**IGEM/UP/10 Edition 4  
COMMUNICATION 1774  
2014**

The following Amendments (March 2016) apply to all copies of IGEM/UP/10 Edition 4 published in 2014.

**IGEM/UP/10 Edition 4  
COMMUNICATION 1774  
2014  
AND COMMUNICATION 1786  
2016**

The following Amendments (February 2017) apply to all copies of IGEM/UP/10 Edition 4 published in 2014 and 2016.

**FIGURE 2 – EXAMPLE OF VENTILATION DISTRIBUTION FOR A PLANT ROOM WITH LOUVRED DOORS AND VENTILATION ◀.**

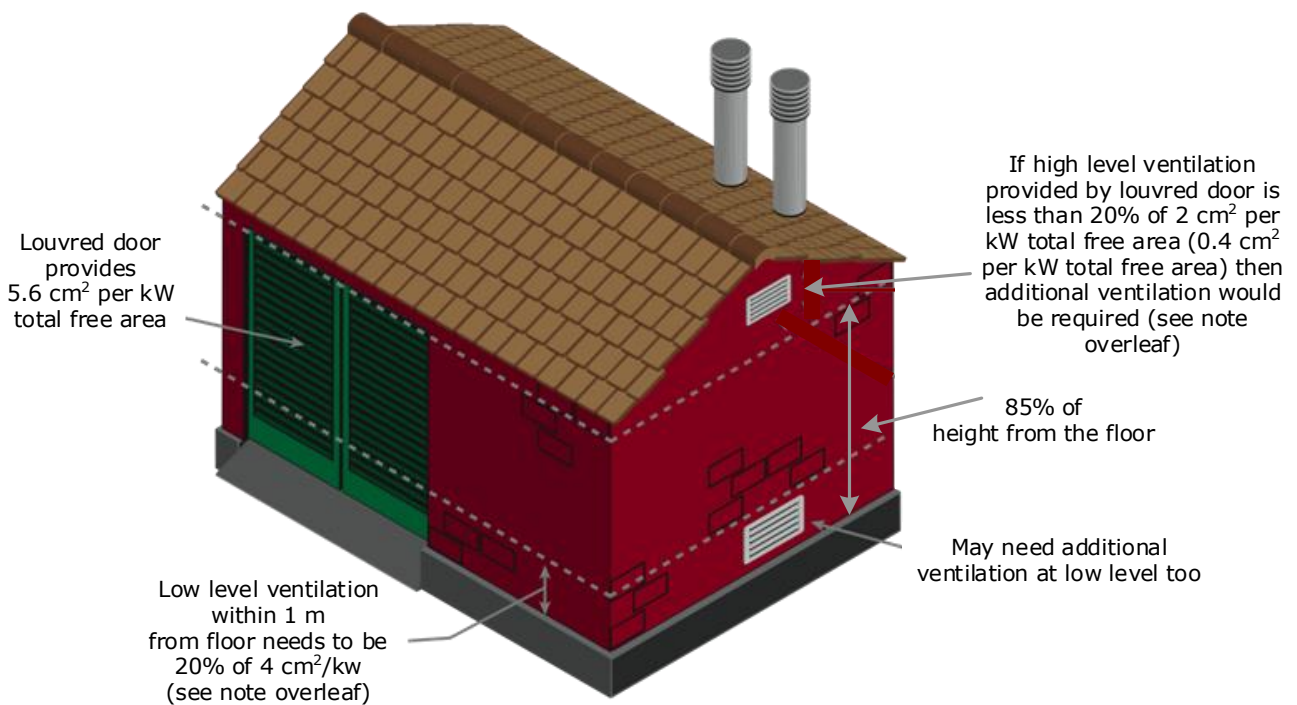
**FIGURE 2 Delete entire Figure. Substitute:**

➤ **FIGURE 6 – EXAMPLE OF TERMINATION POSITIONS ◀**

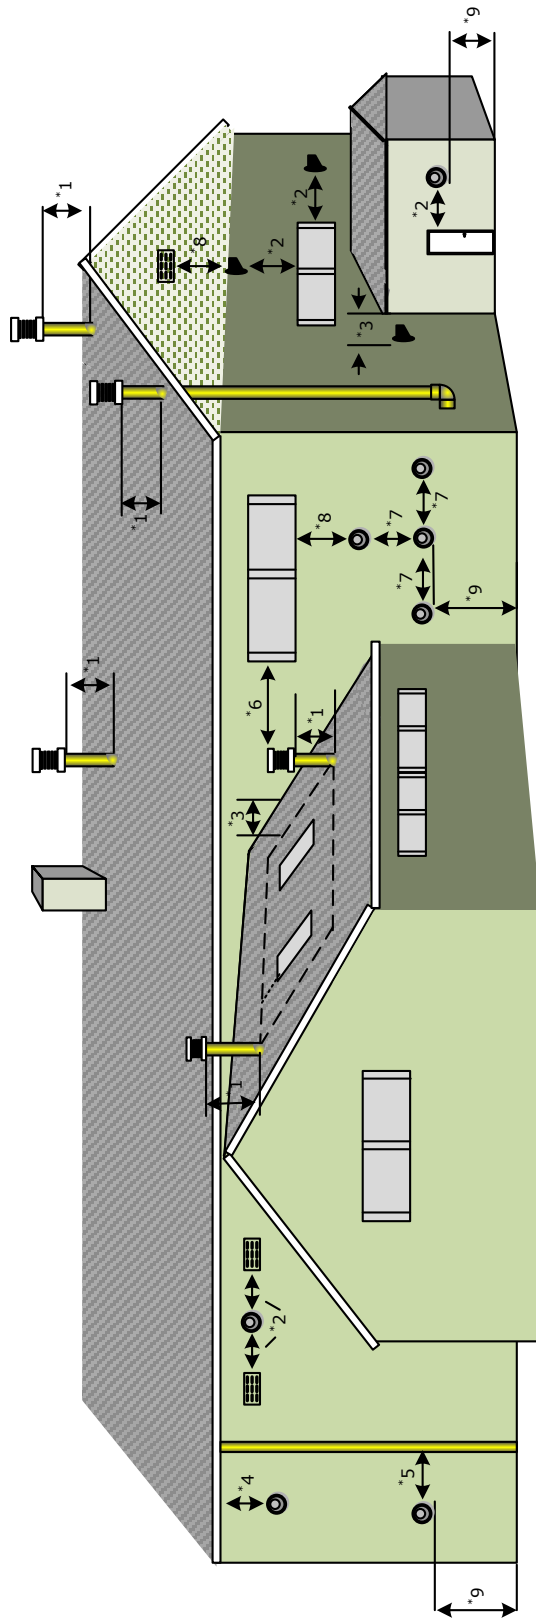
**FIGURE 6 Delete the Figure. Substitute:**

**FIGURE 8 – HEIGHT 'X' OF THE FLUE TERMINAL LOCATED ON A ROOF FOR APPLIANCES UP TO A NET HEAT INPUT OF 333 kW ←.**

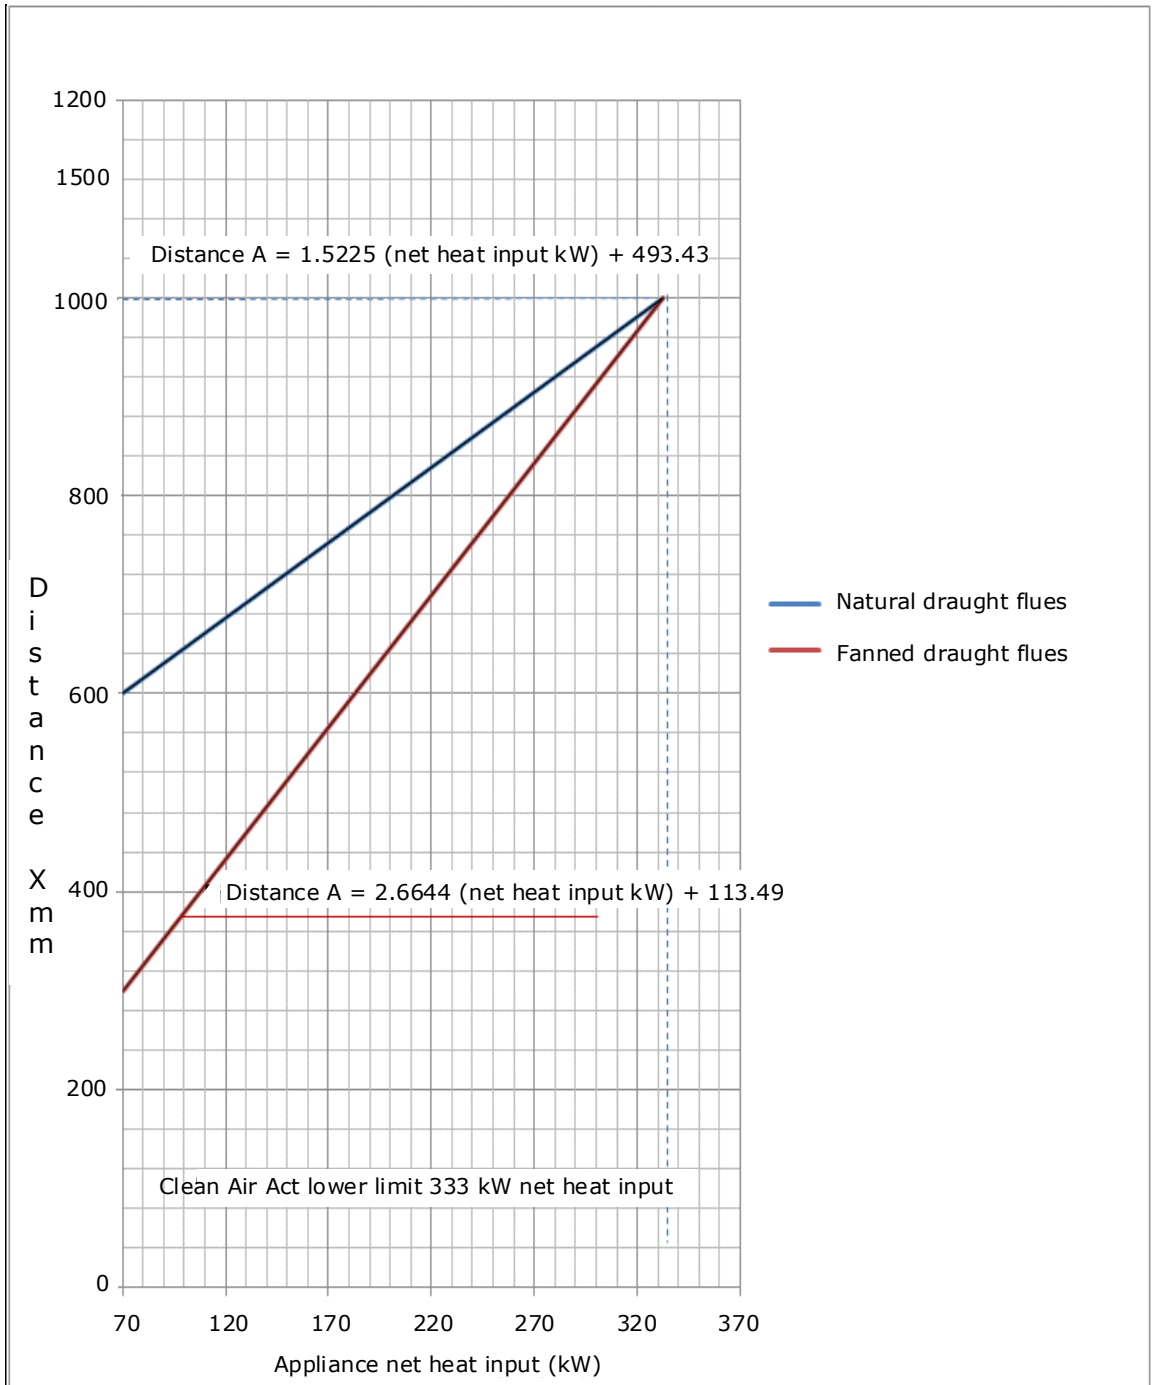
**FIGURE 8 Delete the Figure. Substitute:**

**FIGURE 10A – TERMINATIONS FOR RIDGED ROOF CONFIGURATIONS ◀**

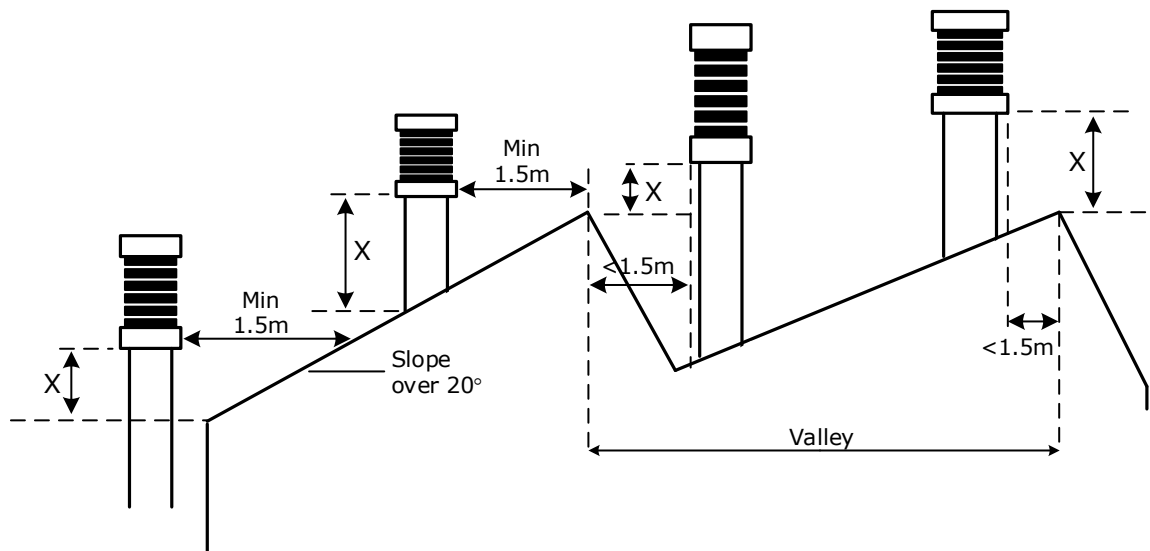
**FIGURE  
10A**

**Delete the Figure. Substitute:**

**FIGURE 11A – FLUE TERMINALS ON AN ADJACENT BUILDING ◀**

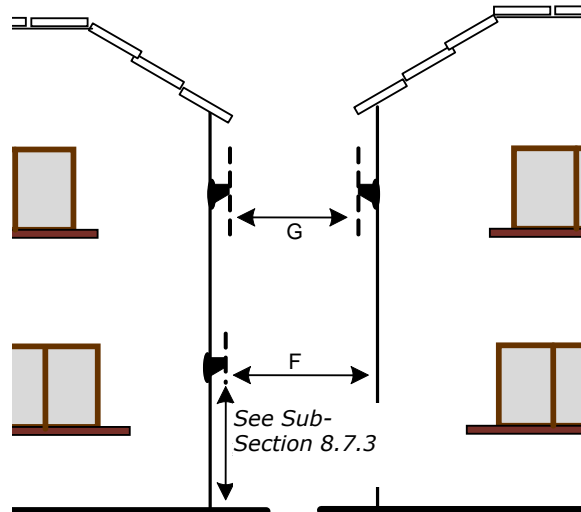
**FIGURE 11A** Delete the Figure. Substitute:

**FIGURE 11B – HORIZONTAL FLUE TERMINALS ENCLOSED BY TWO OR MORE VERTICAL WALLS (PLAN VIEW) ◀**

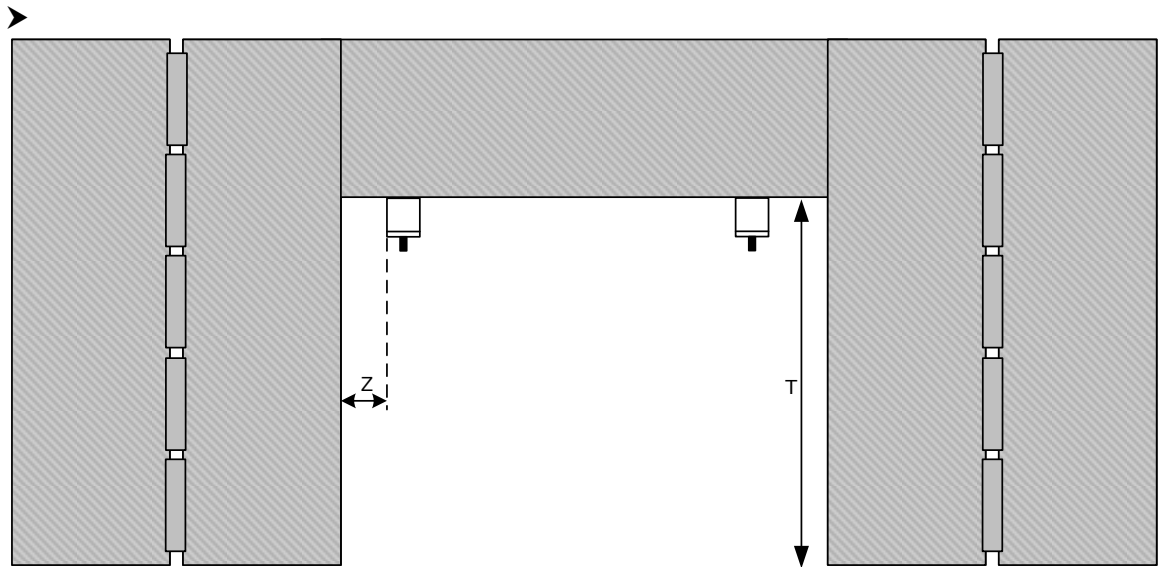
**FIGURE 11B Delete Figure. Substitute:**

**FIGURE 12 – MINIMUM SPACING OF ROOM SEALED APPLIANCE FANNED DRAUGHT TERMINALS FROM OPPOSING FLAT SURFACES 'F' AND OTHER TERMINALS 'G' <**

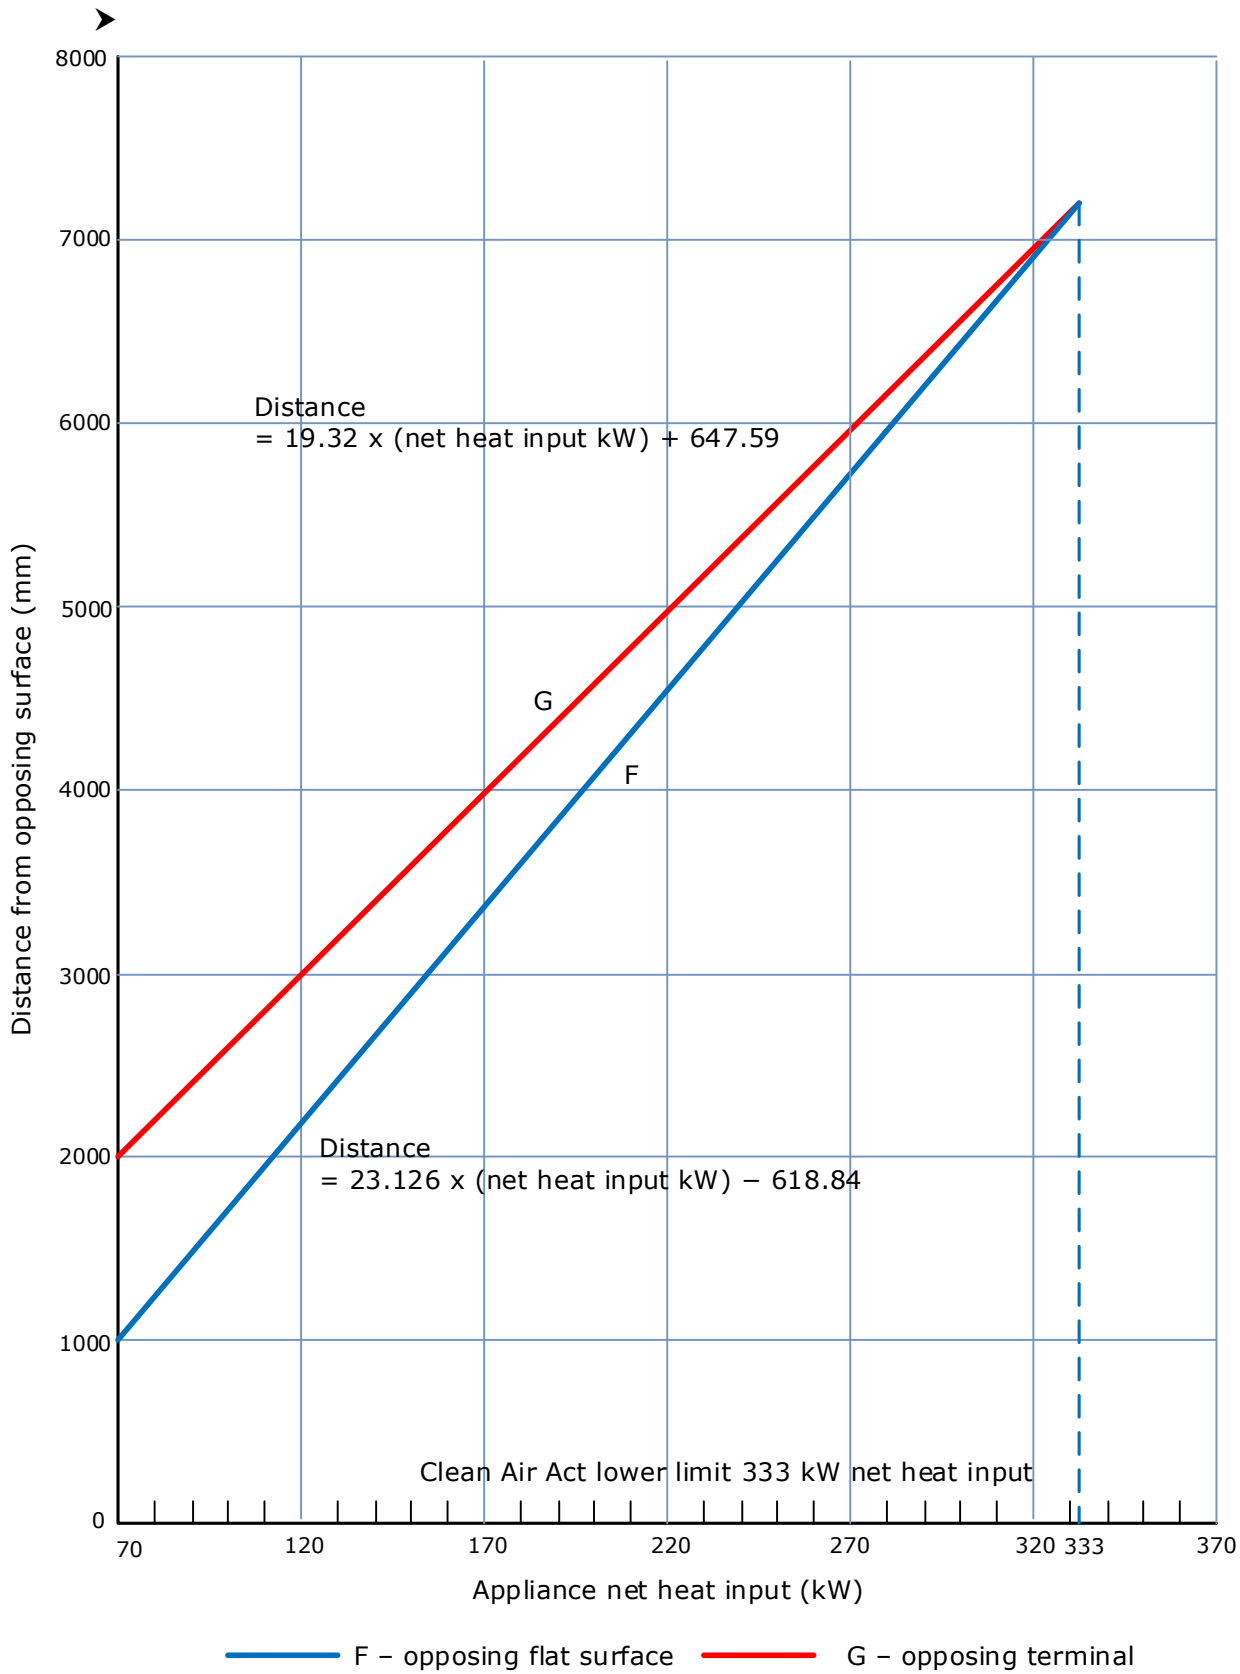
**FIGURE 12 Delete the Figure. Substitute:**

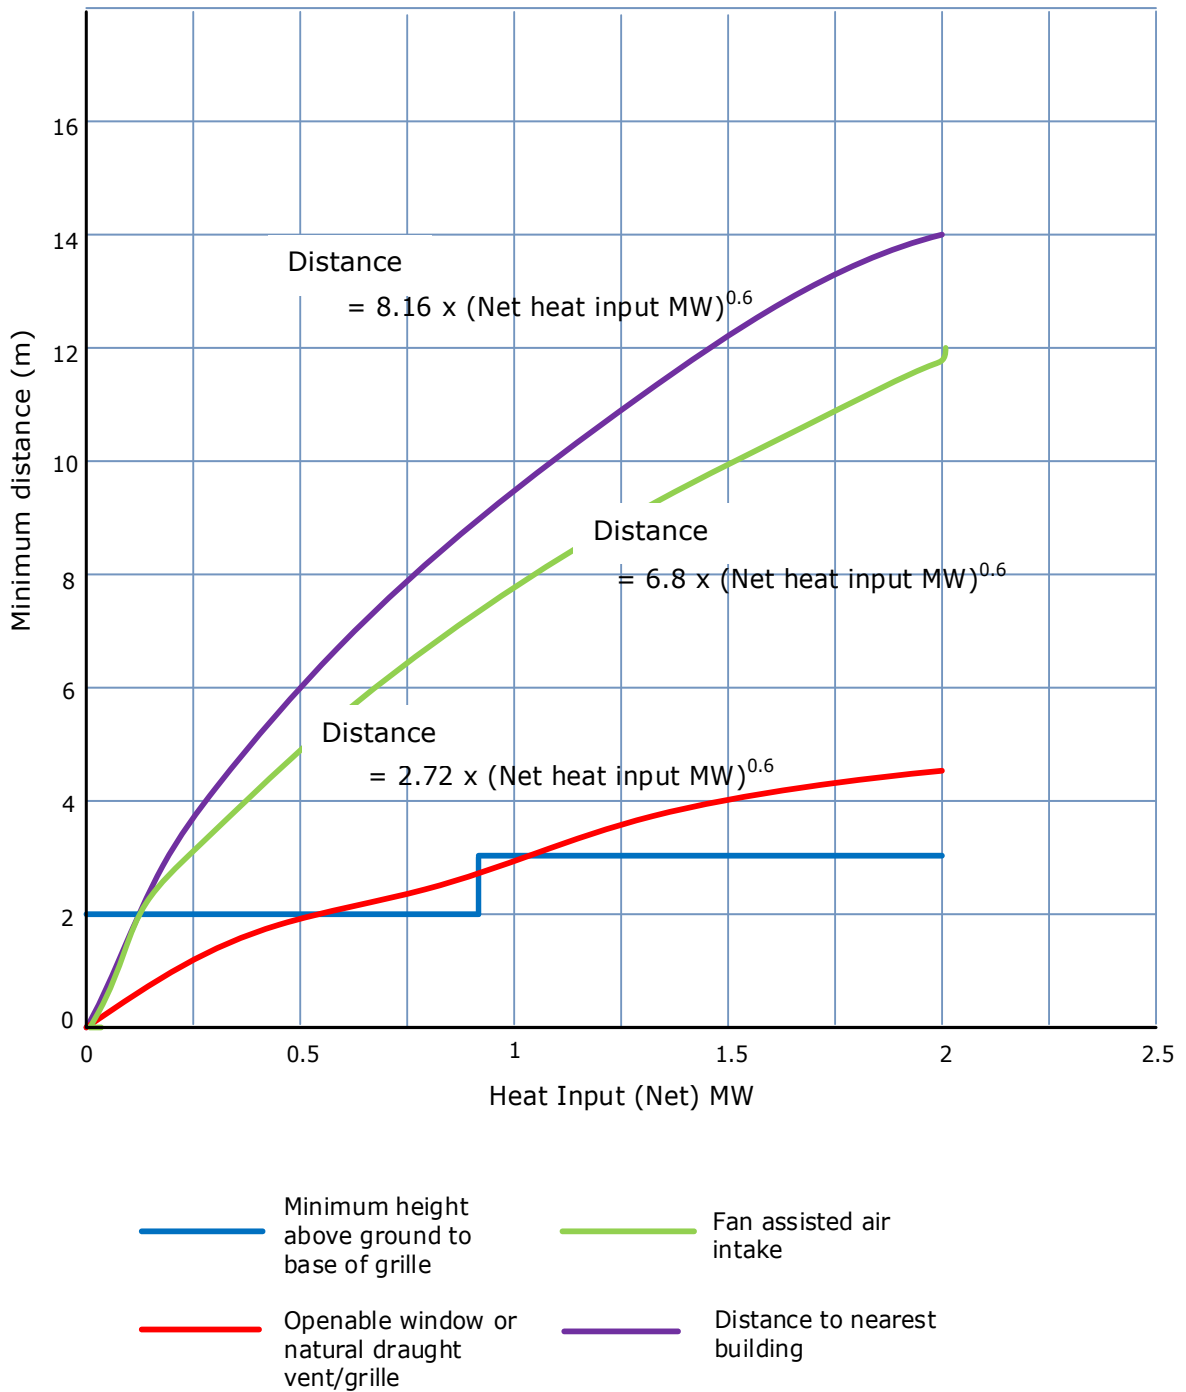
**FIGURE 13 – Delete the Figure. Substitute:**

**FIGURE 7 – THE MINIMUM DISTANCE OF FLUE TERMINAL(S) FROM ANY OPENING INTO A BUILDING <<**

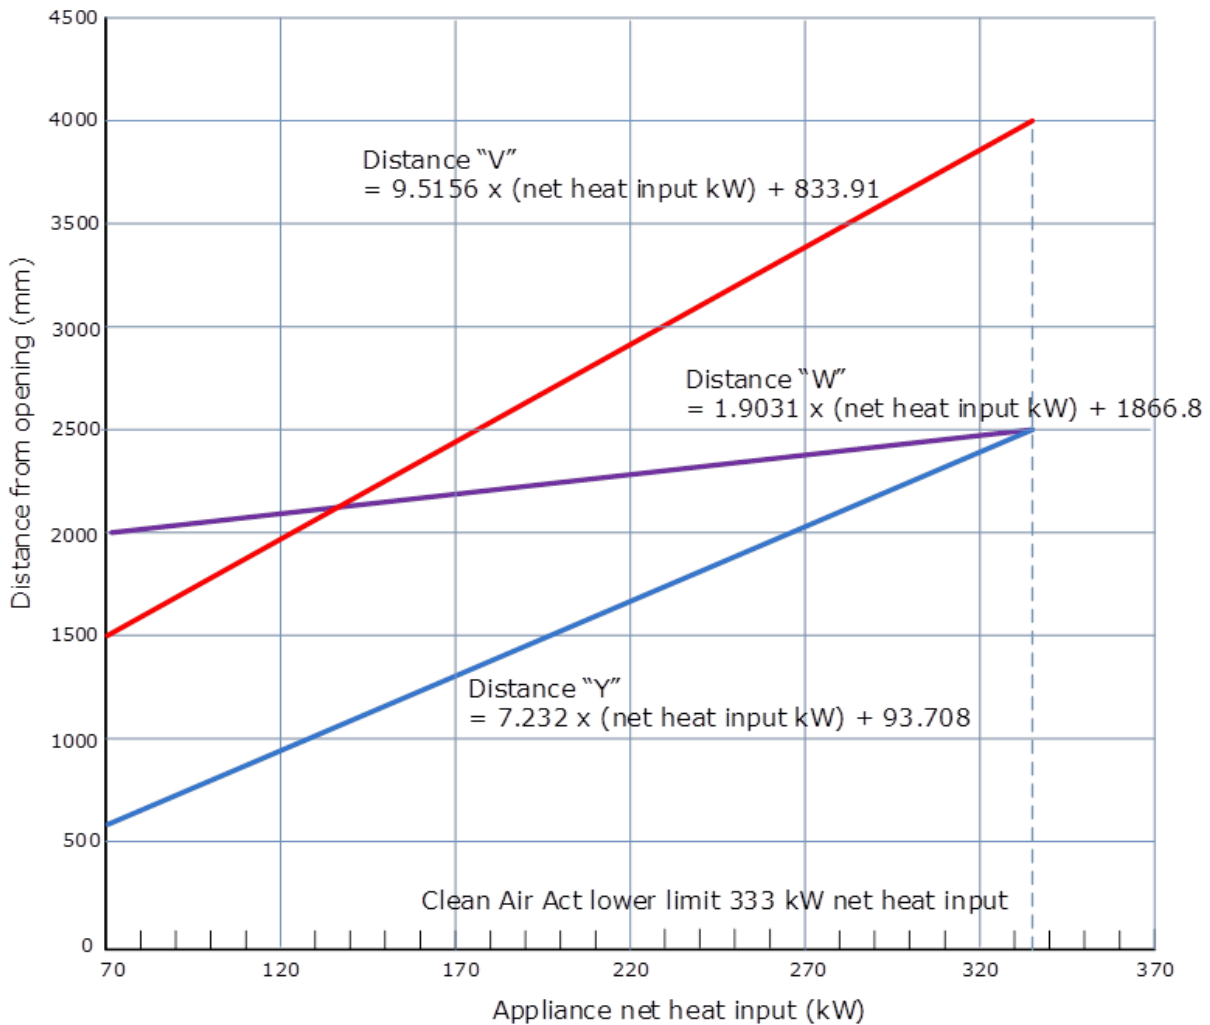
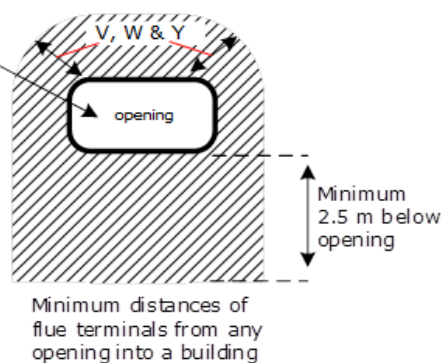
**FIGURE 7 Delete the Figure and substitute:**
